## REVISED RESPONSE TO REQUEST FOR ADDITIONAL INFORMATION

### APR1400 Design Certification

Docket No. 52-046

**RAI No.:** 252-8299  
**SRP Section:** 03.07.02 – Seismic System Analysis  
**Application Section:** 3.7.2  
**Date of RAI Issue:** 10/19/2015

Figure 40. Comparison of Transfer Functions of 9756 Node at Basemat Bottom Elevation (S2 Soil Profile, Cracked Concrete Stiffness Case)

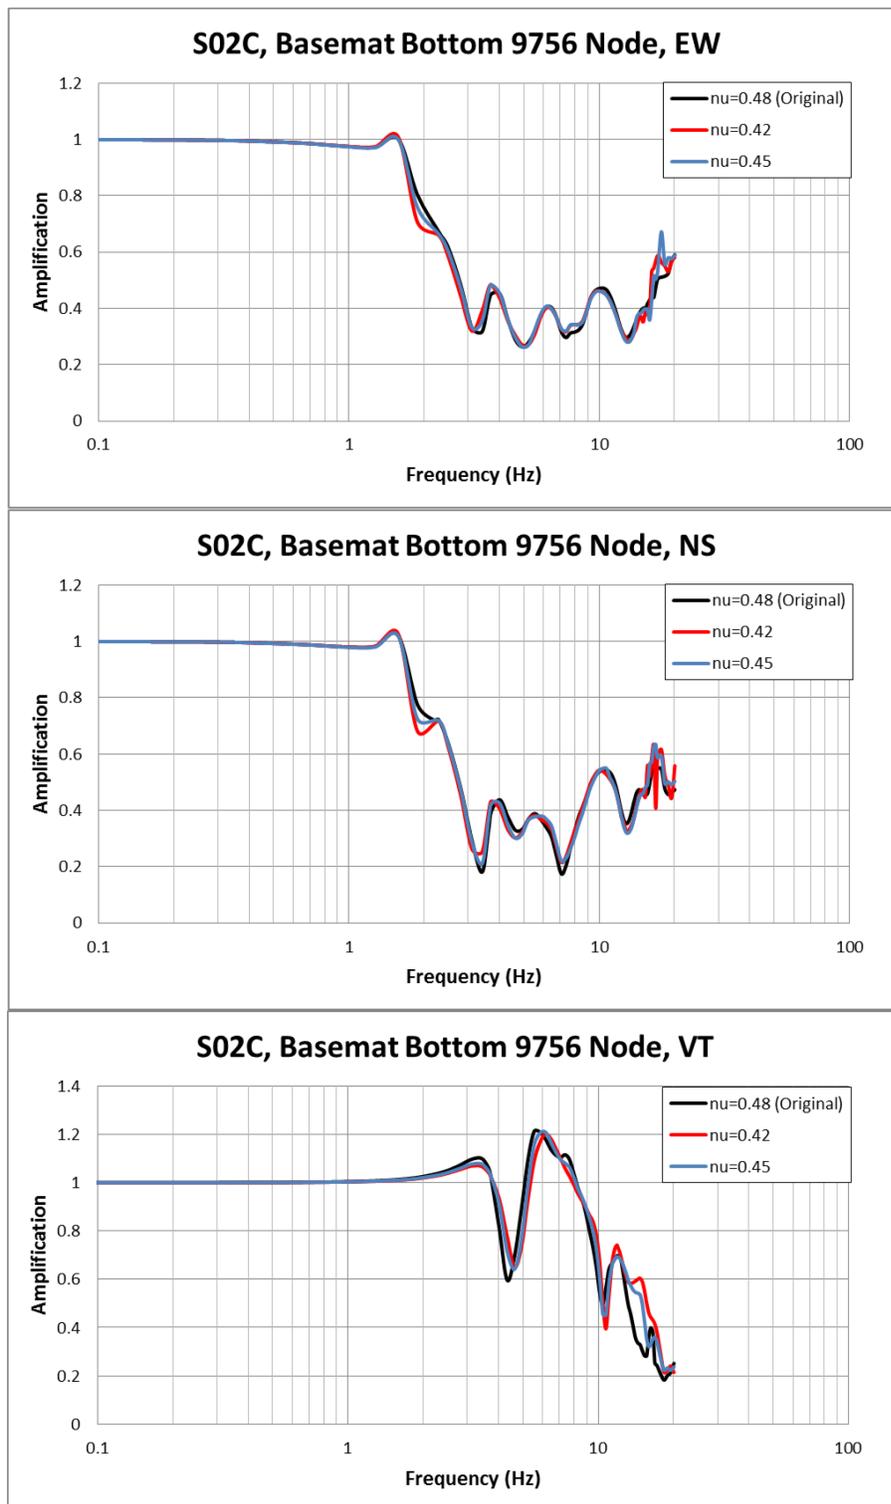
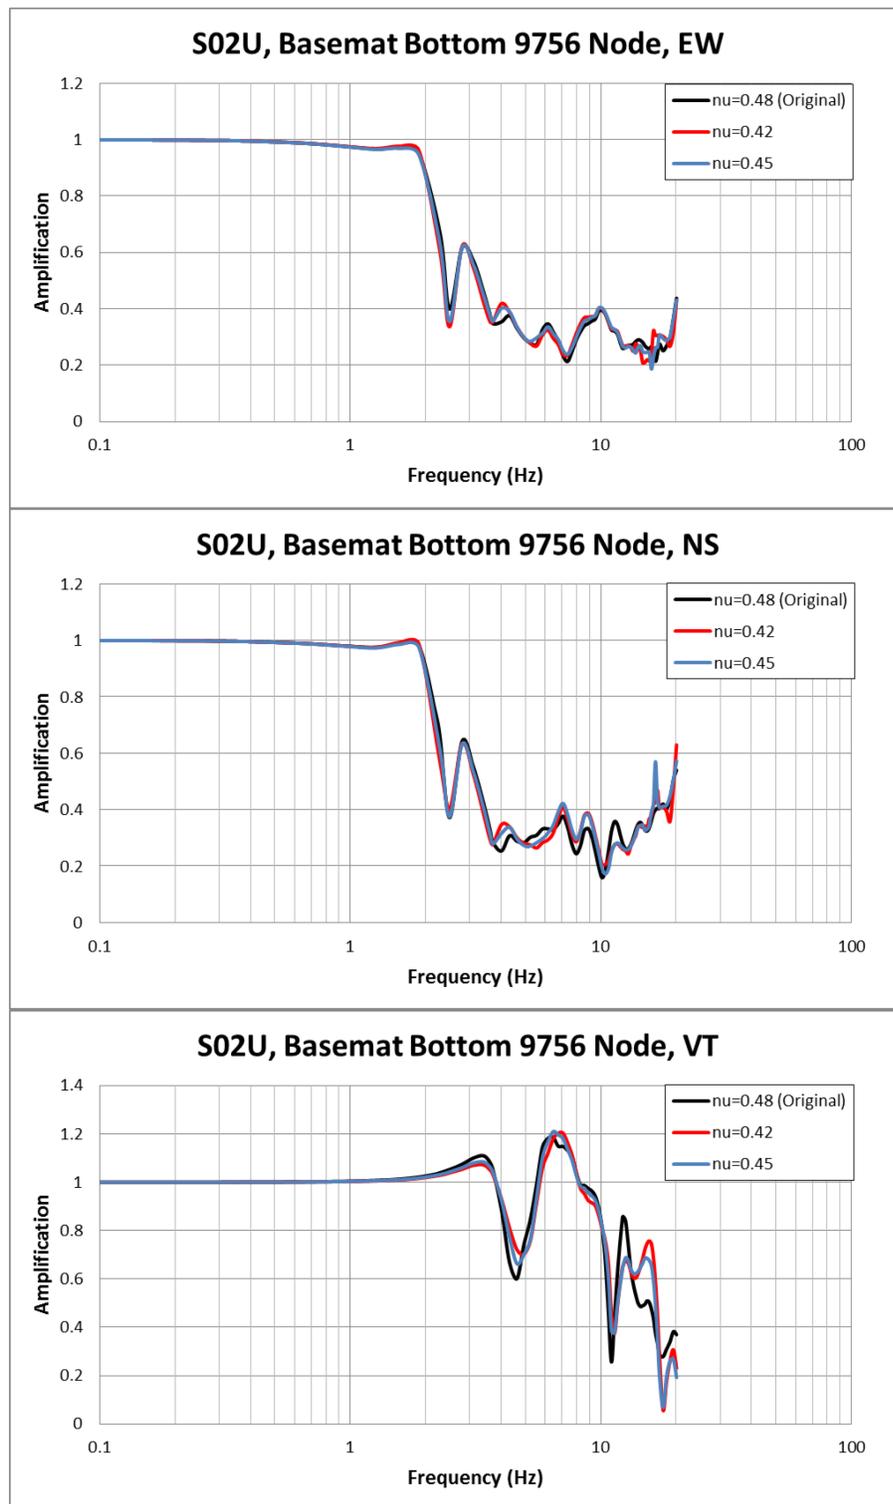
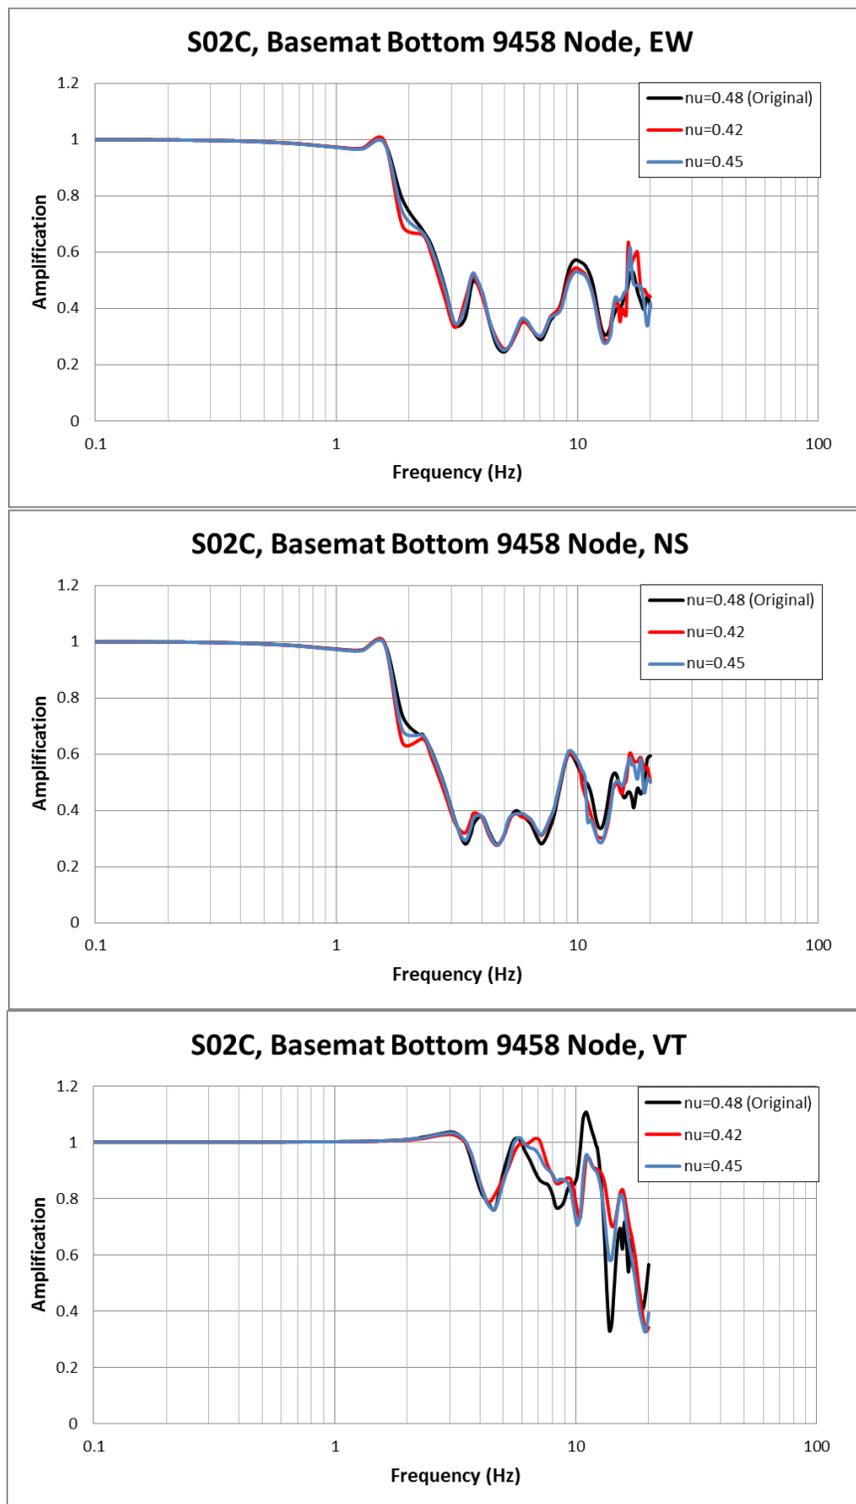
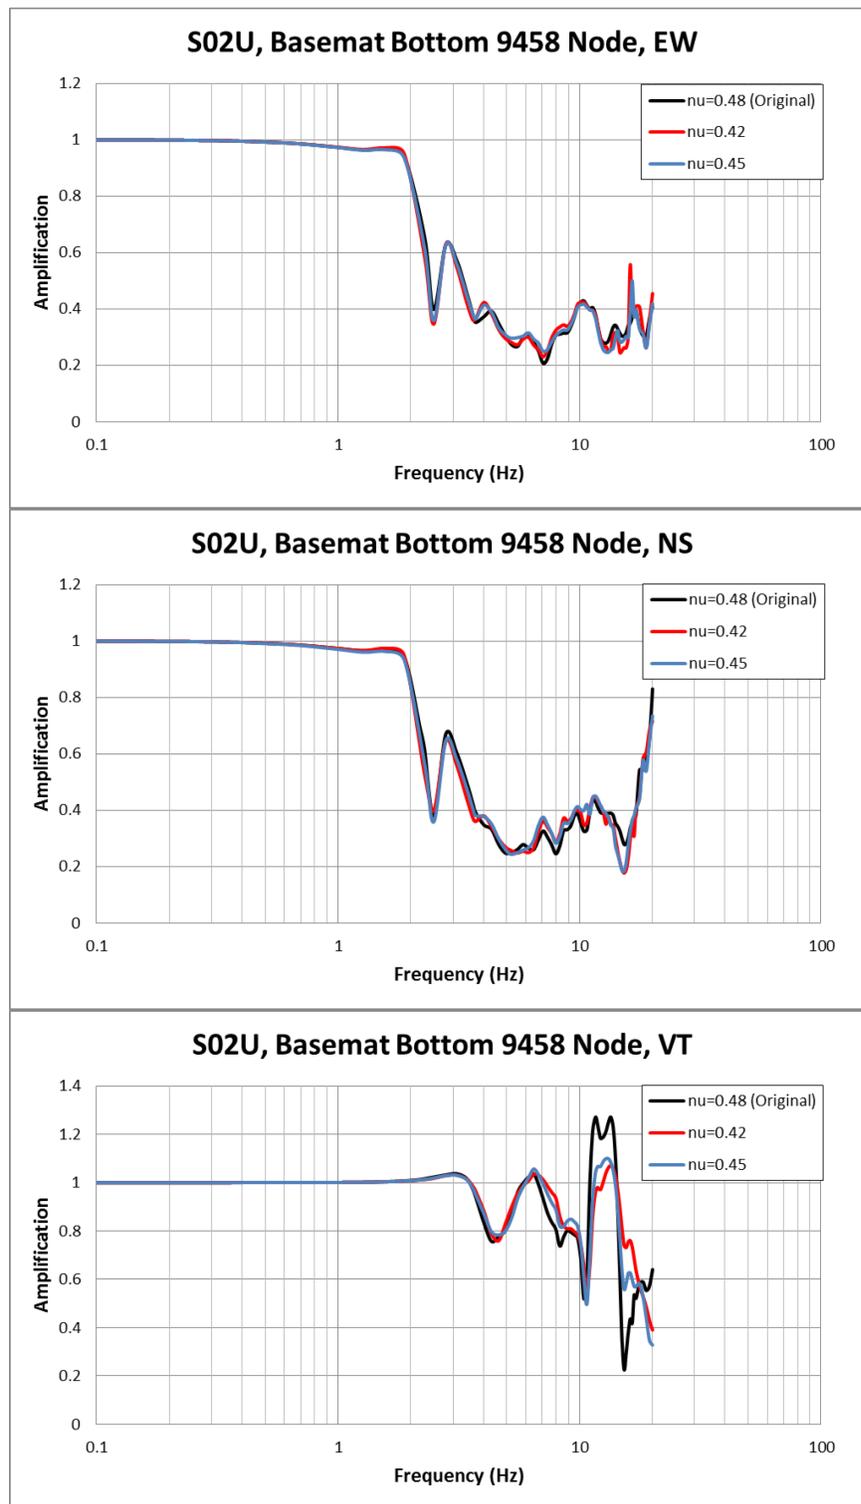
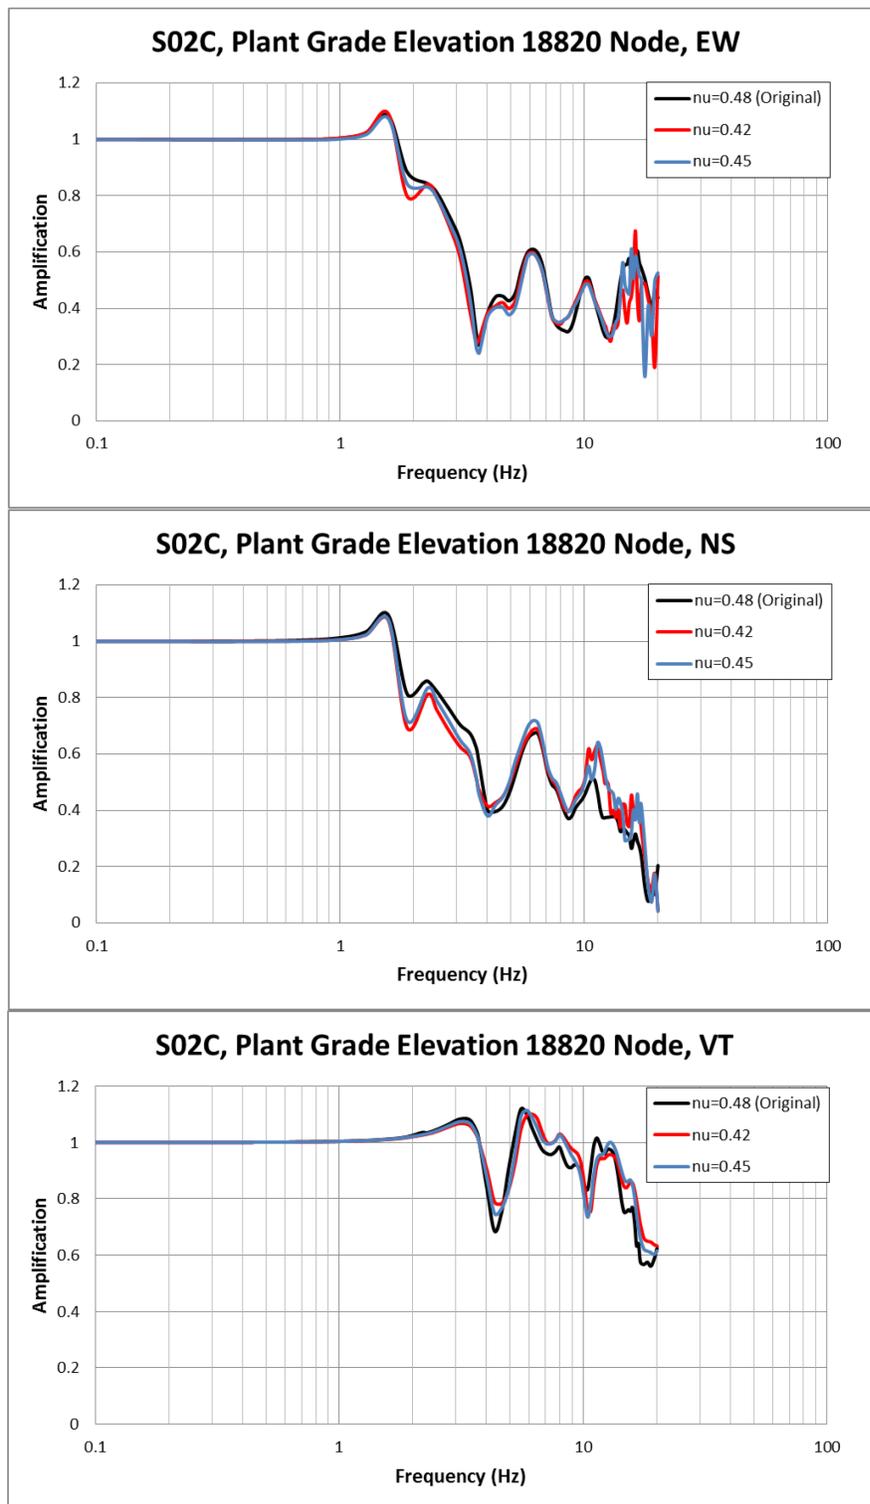
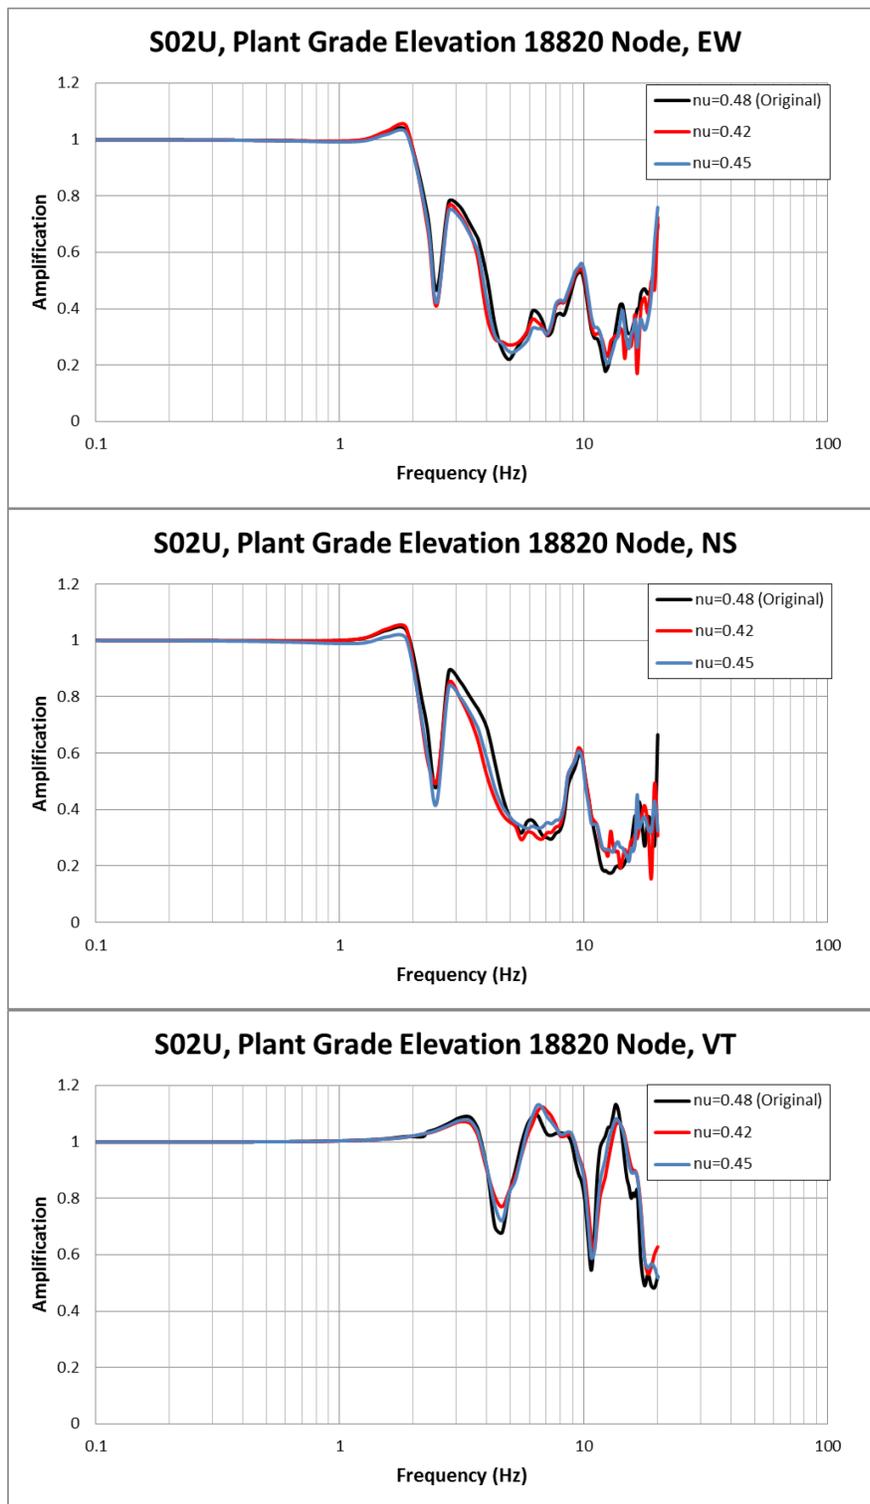
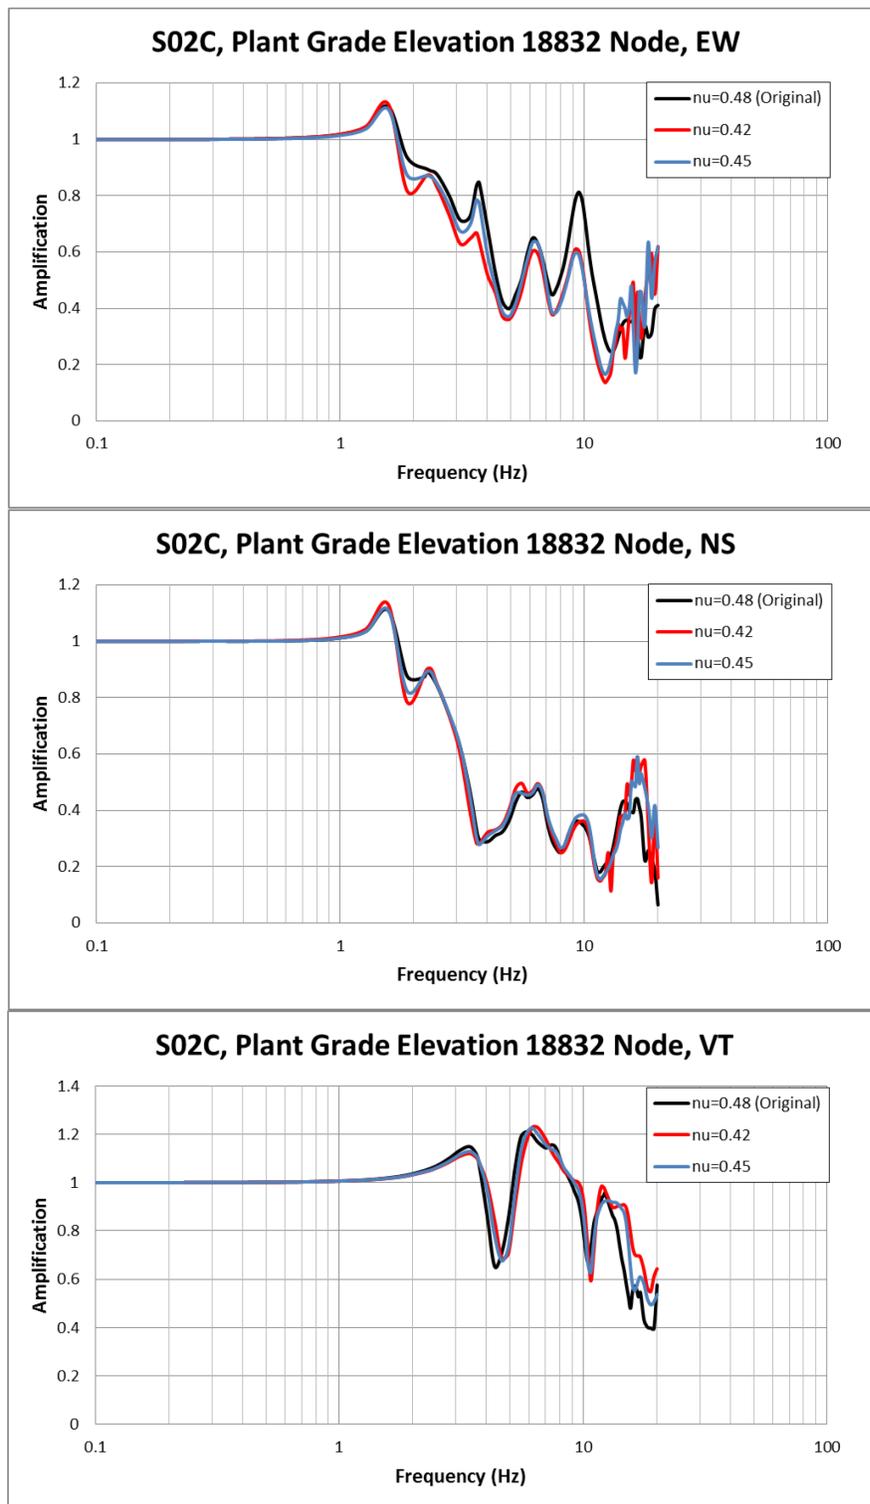
e) Poisson's Ratio Used in SSI Analyses

DCD Tables 3.7A-1 and 3.7A-2 show Poisson's ratios in the S1 and S2 soil profiles used for SSI analysis as great as 0.47 and 0.48 respectively. Based on staff experience, use of Poisson's ratio approaching these values may result in numerical instability of the SSI analysis results. Therefore, to assist the staff in evaluating the adequacy of the SSI analysis results based on the aforementioned soil profiles, the staff request the applicant to provide a demonstration (e.g. sensitivity study) that the assumed Poisson's ratio values do not produce numerical instabilities in the SSI results based on these profiles.

Using the modified soil profiles of S1 and S2, SSI analyses of NI models of both cracked and uncracked concrete stiffness cases are re-performed. Then, the transfer function results at NI basemat bottom and plant grade elevations obtained from the original SSI analyses and the re-performed SSI analyses in the sensitivity study are compared to judge the existence of numerical instabilities in the original SSI results. The locations of the selected nodes at basemat bottom and plant grade elevations using in the comparisons are provided in Figures 18 and 19. The comparisons of transfer function results for S1 and S2 soil profile cases are presented in Figures 20 through 51.

As shown in the comparisons of transfer functions presented in these figures, the transfer functions obtained from the original SSI analyses are quite similar and comparable to the transfer functions obtained from the sensitivity study re-performed SSI analyses. In addition, no abrupt changes or spurious peaks, which tend to indicate existence of

numerical sensitivities in the SASSI solutions, appear in the computed transfer functions of the original SSI analyses that have the maximum dynamic Poisson's ratio values of 0.47 and 0.48 as well as in the re-computed transfer functions that have the maximum dynamic Poisson's ratio values limited to 0.42 and 0.45. These results demonstrate that there is no numerical instabilities in the original SSI analysis results of the S1 and S2 soil profile cases.
